Addendum / Addenda

Project Description / Description de projet U66 Chiller Replacement.		
Solicitation No./N° de sollicitation 16-22146	Project No./N° de projet 5201	W.O. No./N° d'ordre de travail A1-006954-06-01
Departmental Representative / représentant ministériel Maurice Richard		Date February 27, 2017
Notice: This addendum shall form part of the tender documents and all conditions shall apply and be read in conjunction with the original plans and specifications.		Nota: Cet addenda fait partie intégrale des dossiers d'appel; toutes les conditions énoncées doivent être lues et appliquées en conjonction avec les plans et les devis originaux.

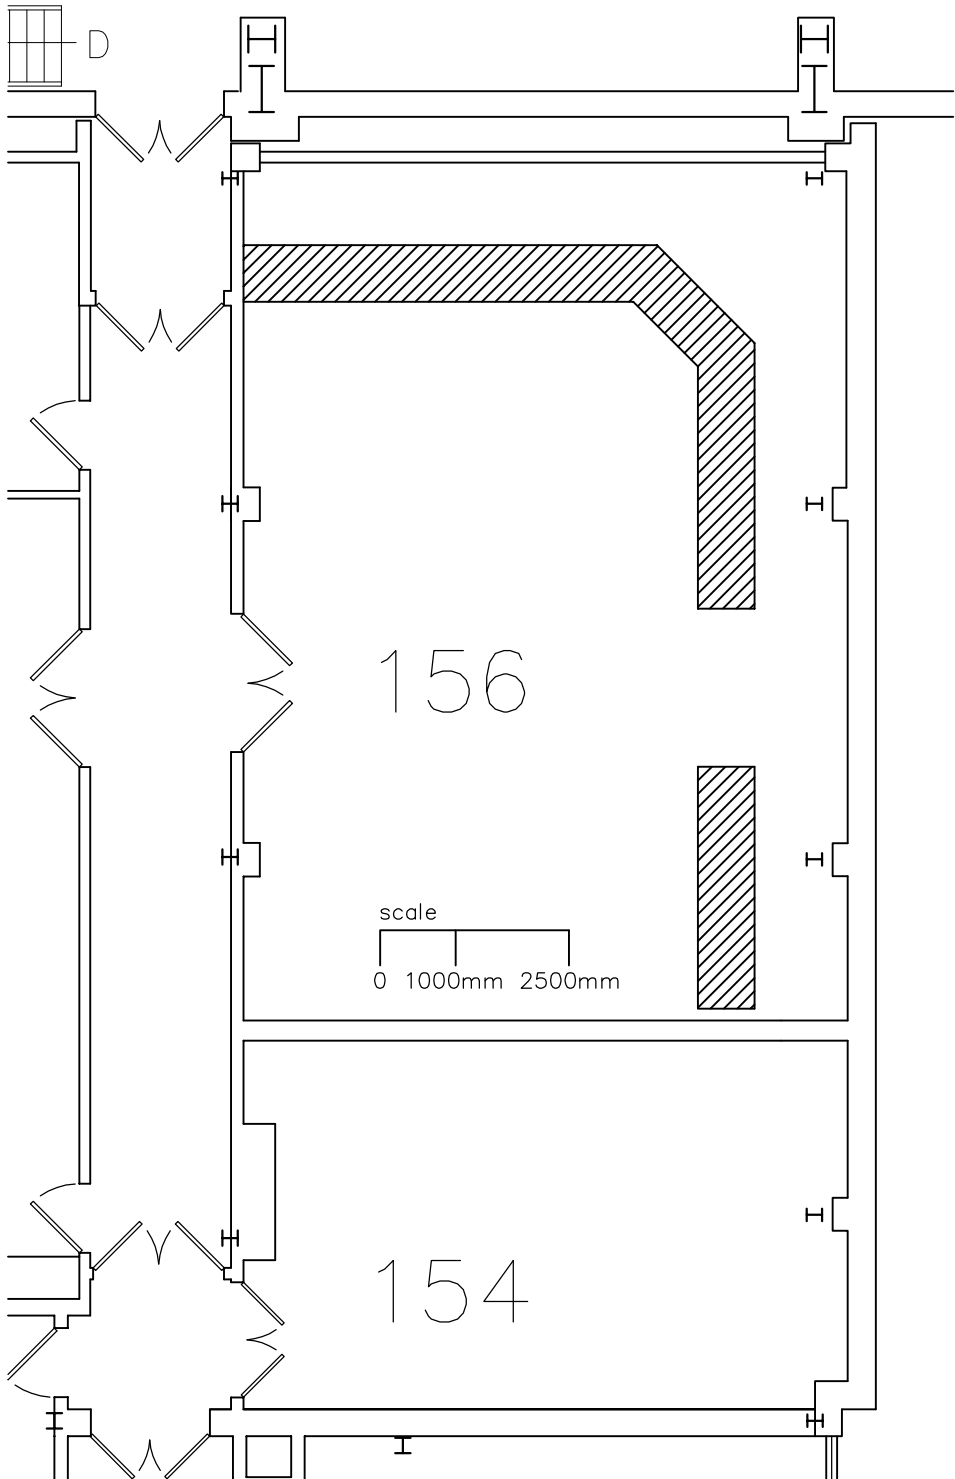
- 3 Ensure the opening of the roof is witnessed by the NRC Departmental Representative so any existing damage can be documented.
- 4 Refer to attached sketch of the stationary equipment in the control room. This is equipment is approximately 750mm deep and 2200mm high. Contractor must adequately protect this from damage during abatement and construction, to the satisfaction of the NRC Departmental Representative. Erect scaffolding above equipment to provide work platform for work to be done above this equipment. The cost of any repairs for damage caused by the general contractor or their sub-contractors will be billed back to the general contractor.
